15/07/2016 T:\2332 Centre Point\02-Sheets\24 Series Stairs Ramps Lifts\2332\24\213\_Eastern External Staircase - Relocated West.dgn 2332 Conran

**MULTIPLEX**  
Title: NUMBERING MARK UP OF EASTERN  
EXTERNAL STAIRCASE  
Drawing number: 2332-24-213-01  
Date: Aug 2016

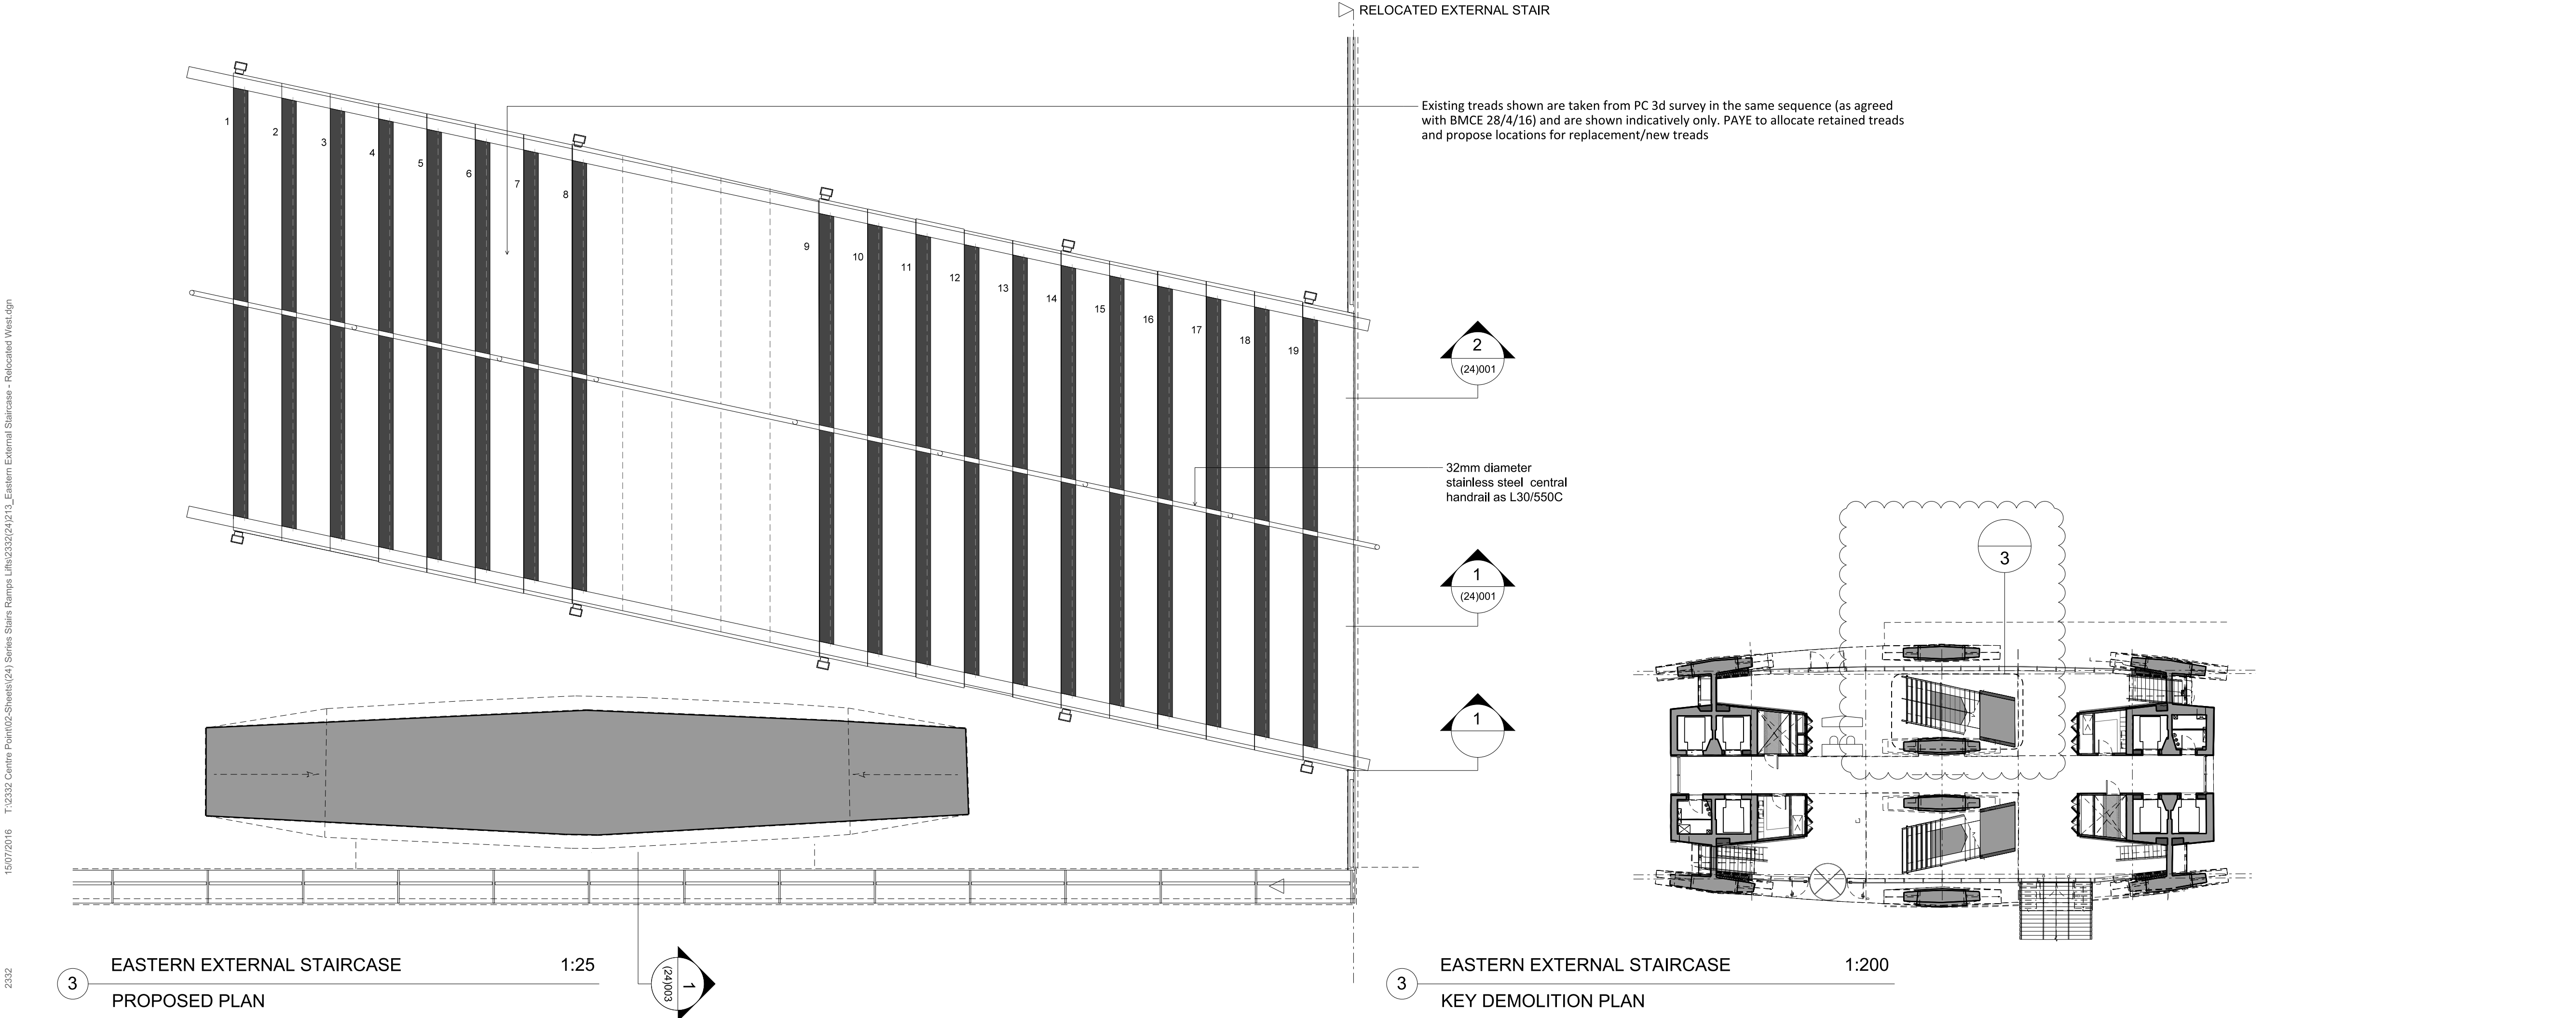
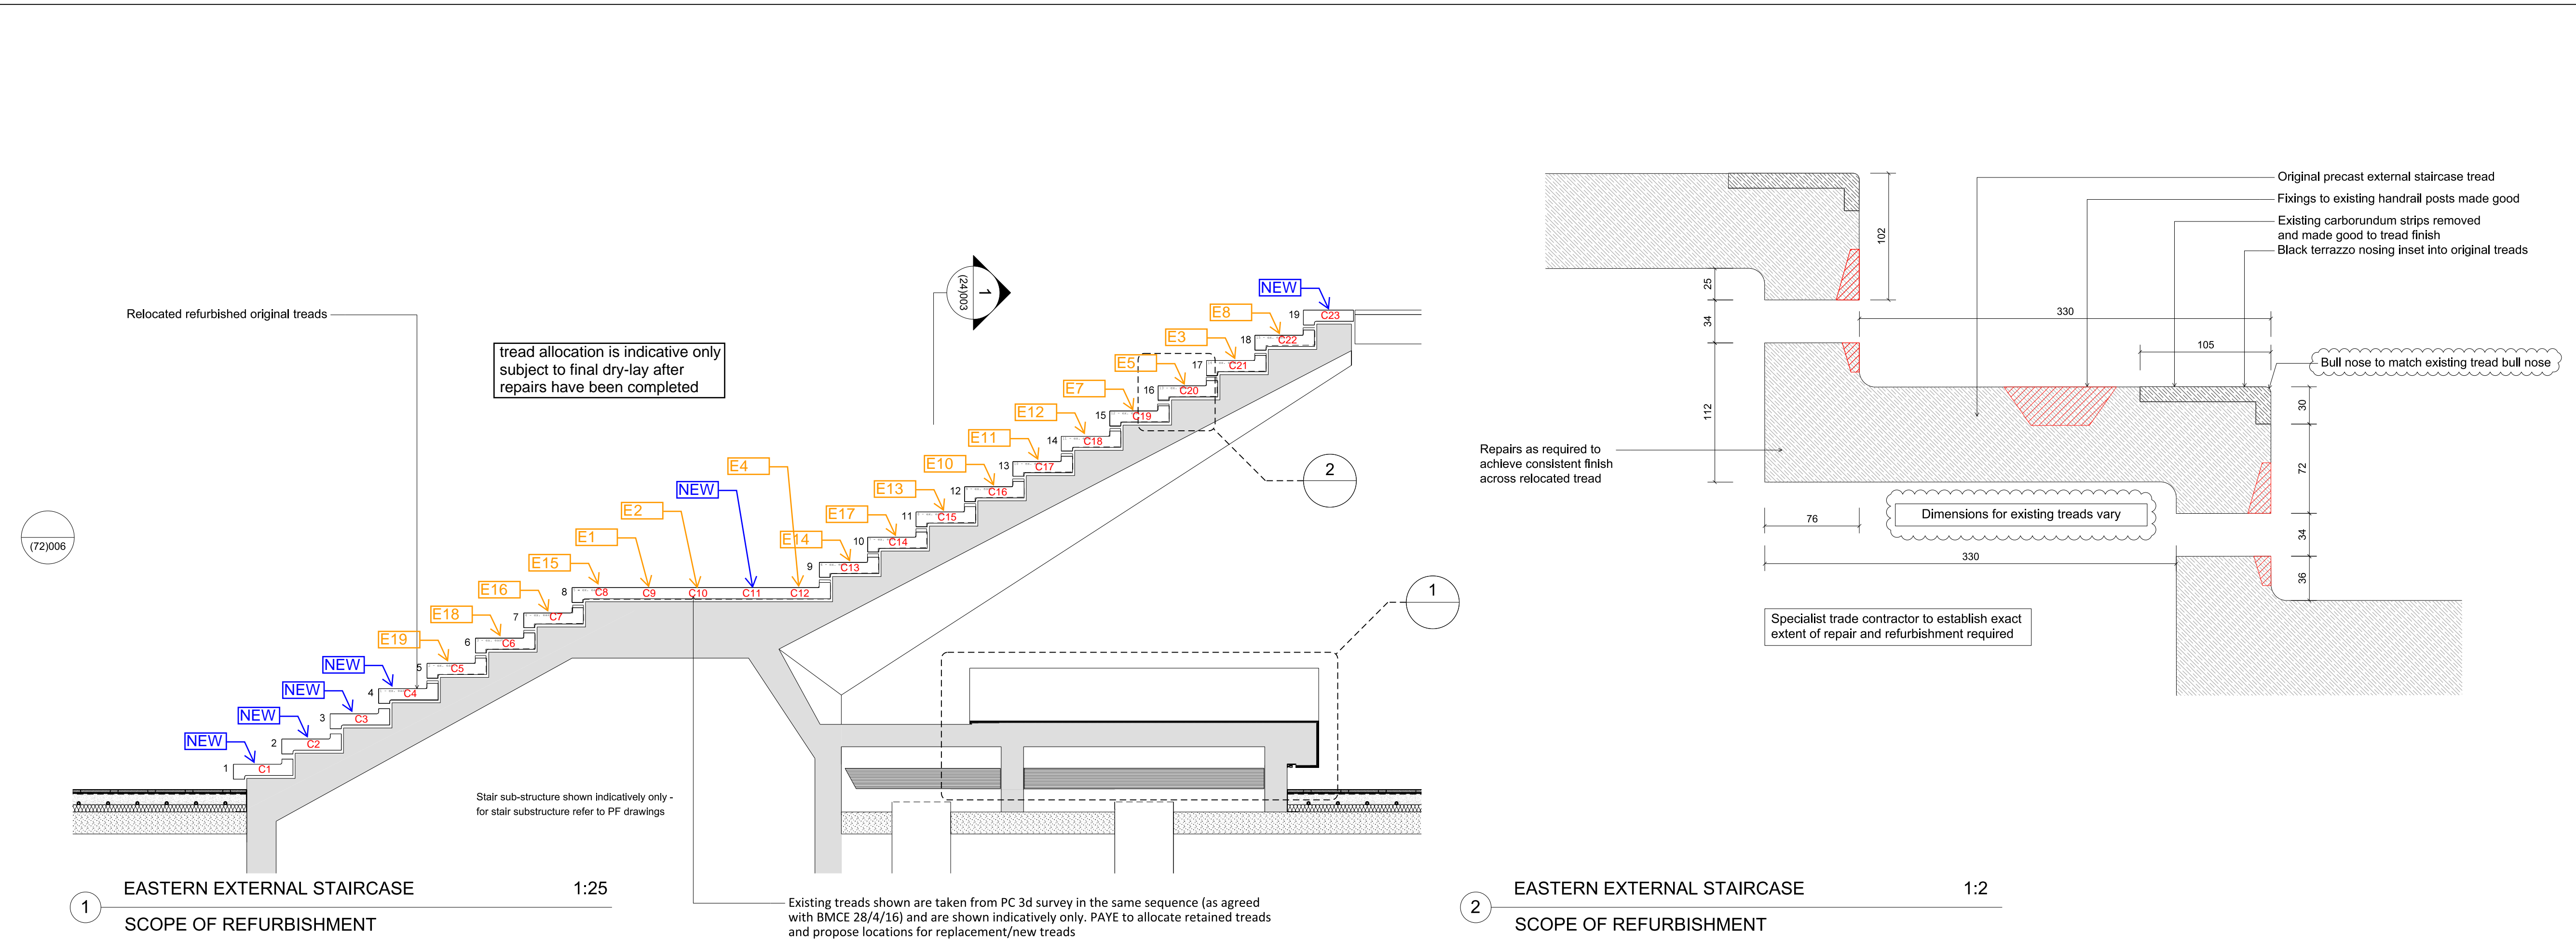
- REPAIR TO EXISTING TREADS
  - NEW TREADS TO MATCH FINISH AND  
PROFILE OF ORIGINAL
  - RELOCATED REFURBISHED  
ORIGINAL TREADS
- C&P recommend that top treads are new (replaced) to ensure  
that upper tread is consistent and parallel to slab (at 10mm). C&P  
recommend that 1st step is new (replaced) tread to maintain  
offset dim shown in C&P drawings.
